Ref. No: 09-6209-SC-91

Re: Revised Submittal  
Site-Wide Supplemental Feasibility Study Part II  
Development and Screening of Remedial Alternatives  
United Nuclear Corporation's Church Rock Tailings Site, New Mexico  
Administrative Order (Docket No. CERCLA 6-11-89)

**Revised Submittal: Site-Wide  
Supplemental Feasibility Study Part II**

United Nuclear Corporation  
Church Rock Tailings Site  
Church Rock, New Mexico

**FIGURE 4**  
**Combined Remedial Alternatives**  
*Shading Indicates Components INCLUDED in Alternative*  
 United Nuclear Corporation Church Rock Site, New Mexico

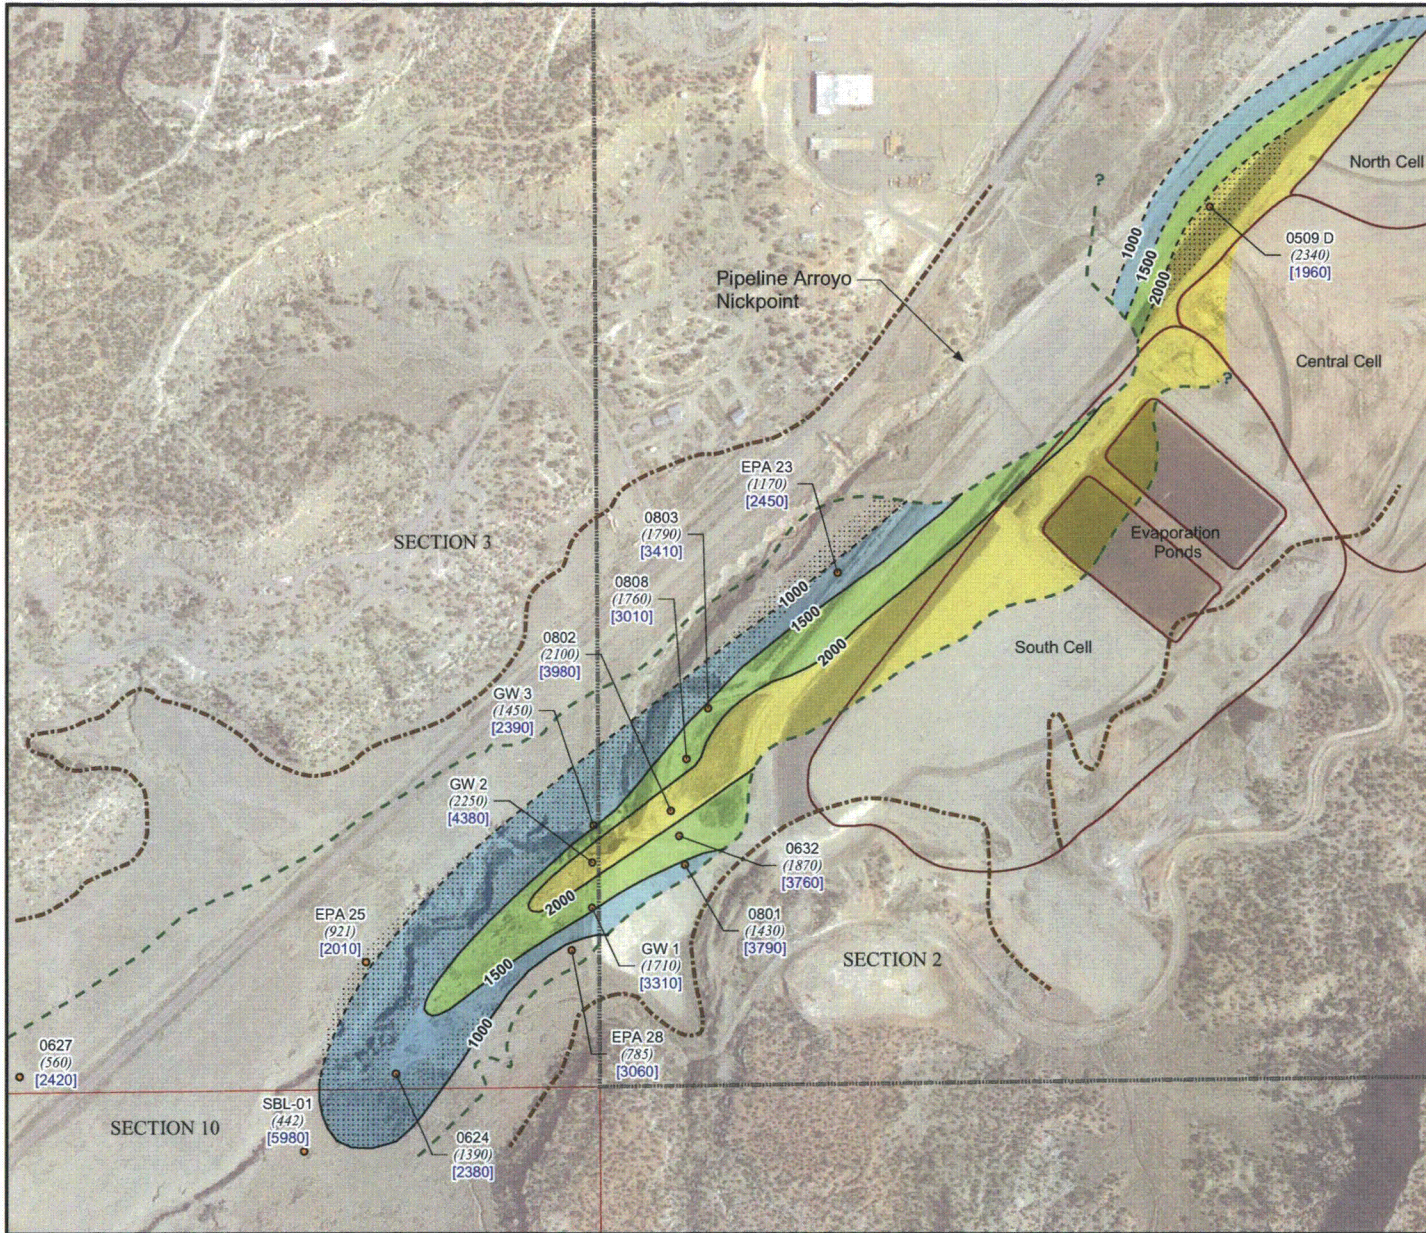
Figure 4 comprises a matrix defined by four combined remedial alternatives in the left column (defining rows in the matrix) and the individual components of the combined remedial

alternatives shown along the various column headers. Six component response actions are broken out for each of the three hydrostratigraphic units. The right-most column indicates that evaporation (part of the current site remedy for Zone 3) is integral to all four of the combined remedial alternatives.

For the Southwest Alluvium and Zone 3, the following groundwater alternatives have been carried forward from the initial screening: containment and extraction (combined remedial alternative No. 1 on Figure 4). For the Southwest Alluvium and Zone 1, the individual alternatives of no further action and ICs survived initial screening. The no further action alternative did not pass initial screening for Zone 3 because the groundwater impacts have not stabilized. The individual alternative of ICs has been applied to Zone 3, although their potential future role in Section 36 is unclear (i.e., turn over of Section 36 to DOE for long-term care).

For the Southwest Alluvium and Zone 3, the following alternatives survived initial screening: (a) containment and extraction (with potential offsite ICs in the Southwest Alluvium and Zone 1 these define combined remedial alternative No. 2 on Figure 4); (b) enhanced extraction (with potential offsite ICs in the Southwest Alluvium and Zone 1 these define combined remedial alternative No. 3 on Figure 4); and (c) hydraulic barriers and extraction (with potential offsite ICs in the Southwest Alluvium and Zone 1 these define combined remedial alternative No. 4 on Figure 4).

As shown in the right-most column of Figure 4, all four of the combined remedial alternatives employ evaporation of extracted groundwater. During the 20 years of active corrective action on the site, including various pumping well arrays in the three hydrostratigraphic units, the extracted water has been effectively managed by evaporation in the two ponds overlying the South Cell.

The combined remedial alternatives may be implemented in ways that deviate from their assembled components in Figure 4. For example, combined remedial alternative No. 3 includes enhanced extraction onsite for the Southwest Alluvium and Zone 3 (this response action did not pass initial screening for Zone 1). This does not mean that enhanced extraction, if chosen for implementation, would necessarily proceed in both hydrostratigraphic units. One should keep in mind that the individual response actions and combined remedial alternatives shown in Figure 4 are those that are feasible based on screening of effectiveness, implementability, and cost.
